Amendments to the Drawings:

REMARKS

FIG. 1A
PRIOR ART

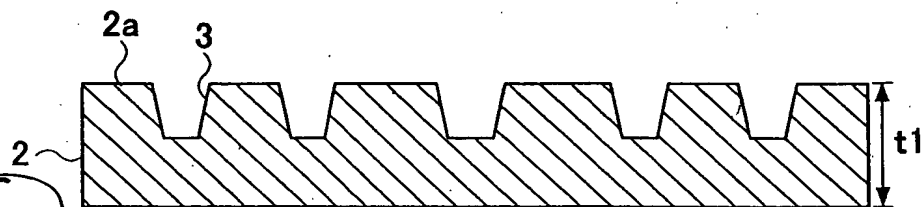
The drawings for the above-identified application were objected to in the Office Action mailed May 17, 2005 because the legend – Prior Art – was missing from FIGS. 1A-1D. Corrections to these figures are shown on the attached copies.

The attached sheets of drawings include revisions to FIG. 1A through FIG. 1D, each of which has been revised to add the legend –PRIOR ART— as required by the Examiner.
